# Townhouse Design Standards

## Planning Commission Study Session #2

# CONCERN #1: OPTIONS RESULTS

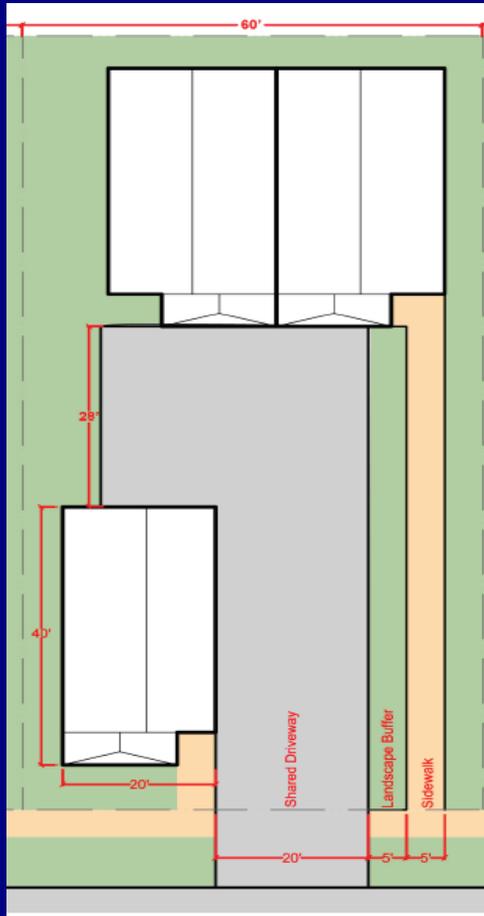
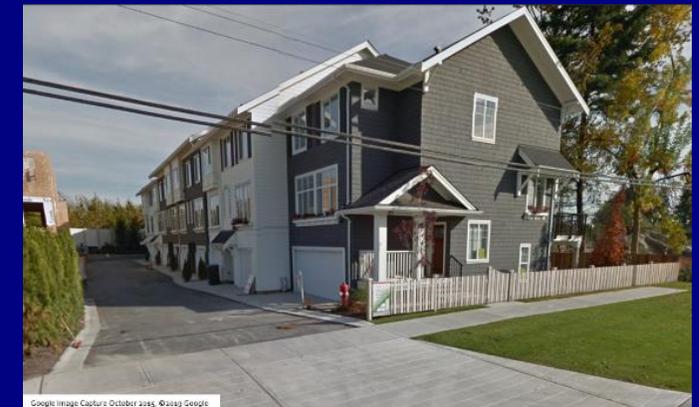
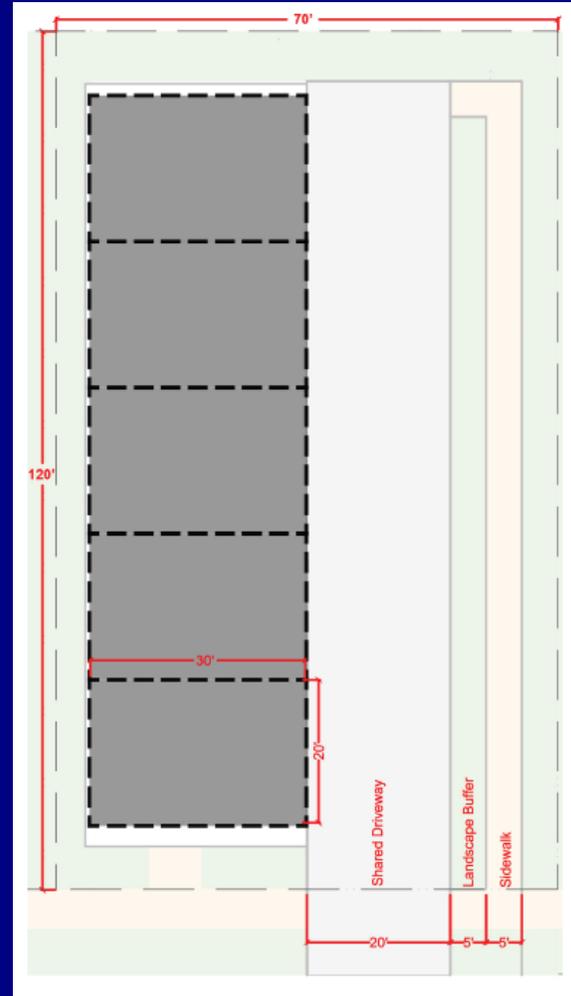
- SMC 20.50.160(C) *Site Configuration* Proposed Language: At least 40 percent of units within a site shall be located between the property line and a 25-foot distance from the property line to create a “street wall” which enhances the streetscape and overall pedestrian experience.
- Commission Comment: Concern that the requirement is conflicting with increased density desired in the MUR-35’ and MUR-45’ zoning districts, particularly on smaller lots.
- Site Design Group Comments (Public Workshop):
  - 40% requirement is too low, but a higher percentage may be impractical
  - Too restrictive on narrow lots
  - Requirement is good for making developments part of the neighborhood
  - Concern about townhouse neighbors overlooking their SFR backyard
  - How would the requirement apply on corner lots?

- Option 1: Keep original 40% language but add the following exception: “On lots 60 feet wide or less, at least 30 percent of units within a site shall be located between the property line and a 25-foot distance from the front property line.”
- Option 2: Re-write the provision: “Buildings shall be located to create a “street wall” which enhances the streetscape and overall pedestrian experience. Except for vehicular access that meets the requirements of the Engineering Development Manual and the Development Code, buildings shall fill the lot frontage. All units with frontage shall be oriented to the public right(s)-of-way.”

Option 1: 60 ft wide only 30%

Option 2: Fill frontage

# CONCERN #1: OPTIONS RESULTS

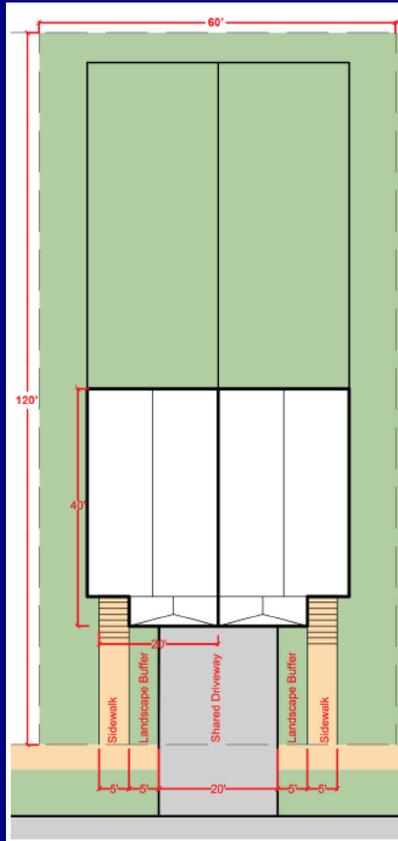
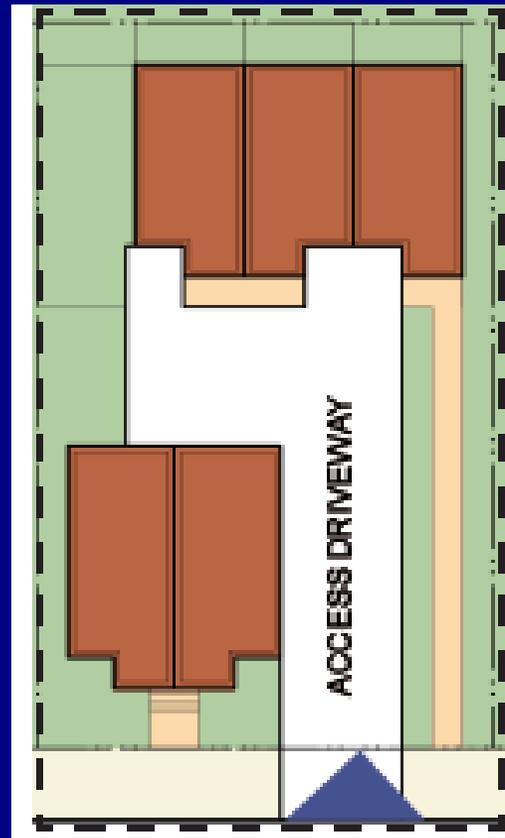
- Fewer Units

- Skinnier Units

- Lot Assemblage

# CONCERN #2: DISCUSSION

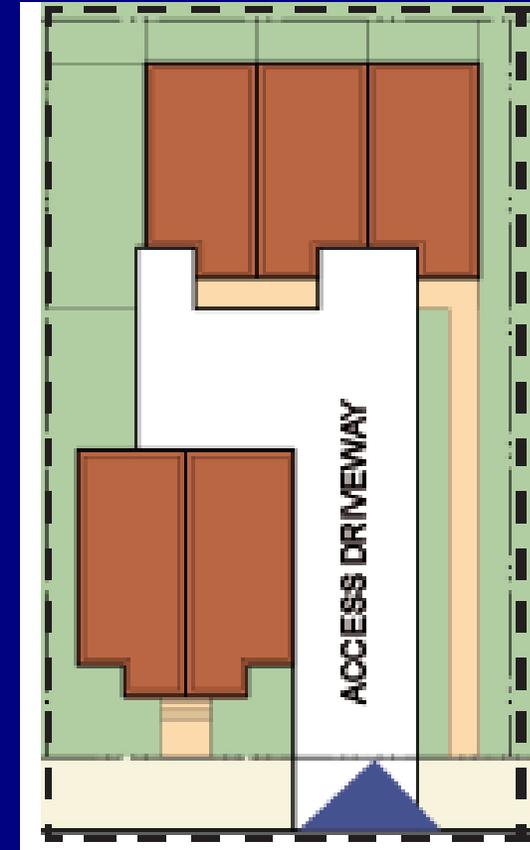
- SMC 20.50.160(D) Site Access and Circulation
- Proposed Language: See pages 10-11 of Attachment A
- Commission Comment: Concern that language on pedestrian connection for each unit is not clear enough to address a site layout where buildings are located in the rear of a lot.
- Proposed language to clarify the requirement: “For buildings that do not front on the public right(s)-of-way, this requirement shall be considered met if pedestrian access is provided from a public sidewalk to the building(s).”

- Proposed language to clarify the requirement:  
“For buildings that do not front on the public right(s)-of-way, this requirement shall be considered met if pedestrian access is provided from a public sidewalk to the building(s).”

# CONCERN #6: DISCUSSION

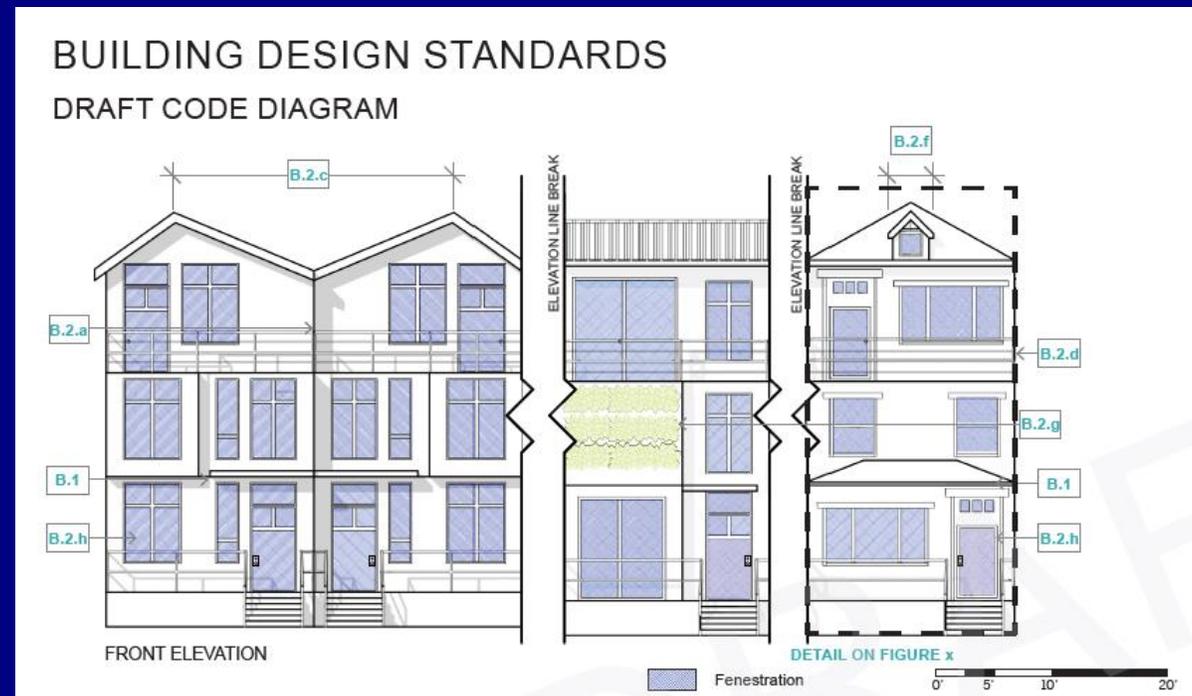
- SMC 20.50.485 and 20.50.490 Landscaping
- Proposed Language: See pages 22-23 of Attachment A
- Commission concern that on lots with a zero (0) front yard setback, the proposal is not requiring that landscaping be provided.
- Potential solution from the Commission: Require that some landscaping is provided for a portion of the area next to a unit entry.
- Site Design Group Comments (Public Workshop):
  - Concern about long-term maintenance of landscaping.
  - Requiring landscaping is important.

- Add the following provision: “If a property has a required setback of zero (0) feet, landscaping shall be provided at a depth of at least four (4) feet and width at least 30 percent of the unit width. The required landscaping shall abut the entry. For example, if the unit width is 20 feet, the landscaping next to the entry shall be a minimum of six (6) feet wide.”
